SEWAGE DISPOSAL SYSTEM

MARYLAND STATE DEPARTMENT OF HEALTH

Bill Ingram IS PERMITTED TO INSTALL ALTER

SUBDIVISION Talley Property ROAD 14954 Bushy Park Road LOT 11

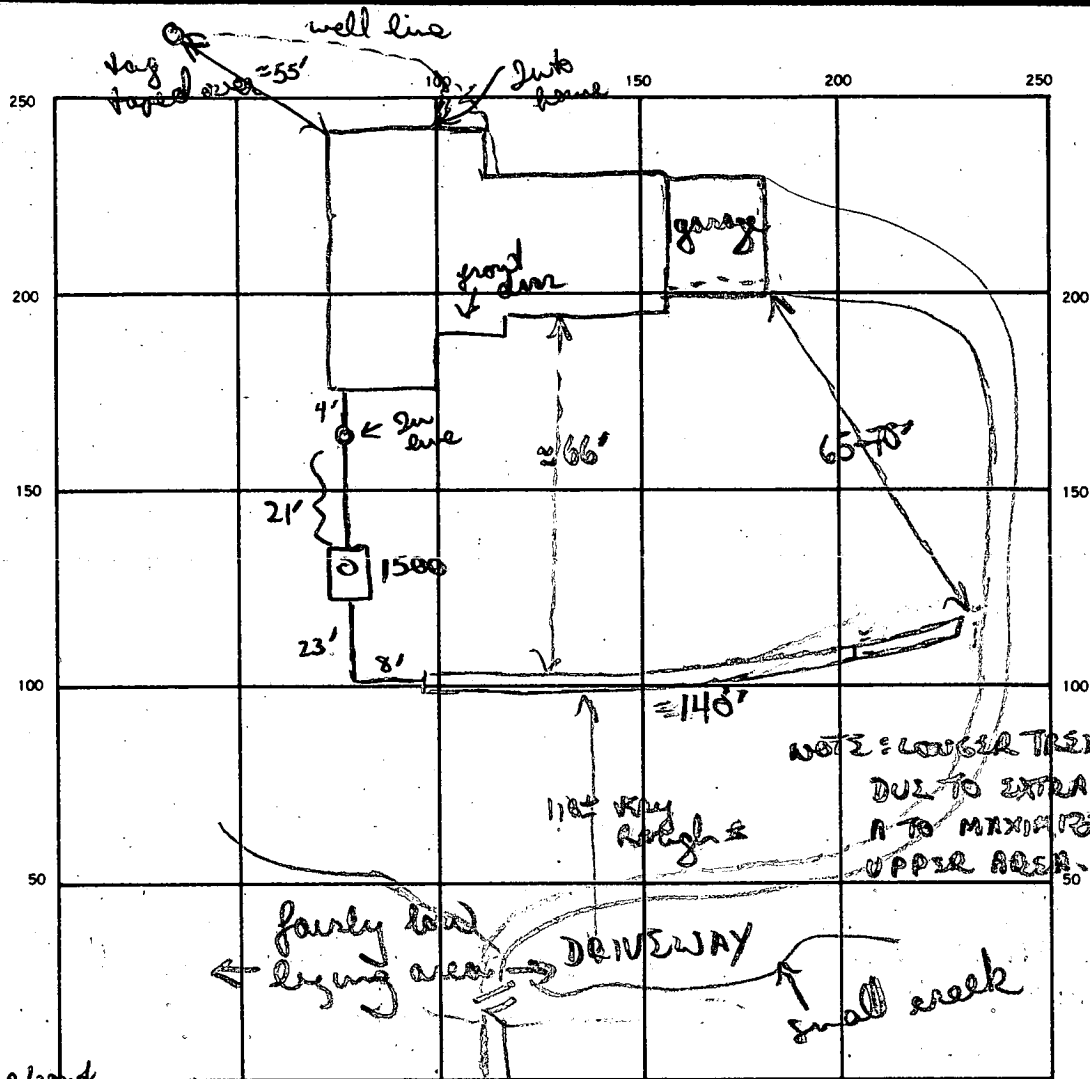
GARBAGE GRINDER? YES NO } ? specs (p/bed) does NOT reflect garbage disposal.

REMARKS 3/8/88 OK to finish piping from In line c/o to septic tank. OK to install S.T. c/o. Square footage NOT sufficient for designed system (even w/ extended trench length). If indeed there is a garbage disposal, definite 2nd trench (55-60' long w/ 4' stone) if no garbage add 28' more of trench (total length = 138-140') to get

SEPTIC TANK CAPACITY 1500 GALLONS NUMBER OF BEDROOMS 3 3/9/88 owner/contractor confirmed no disposal

3/9/88 trench extended - no 2nd installed. OK to cover trench & all work
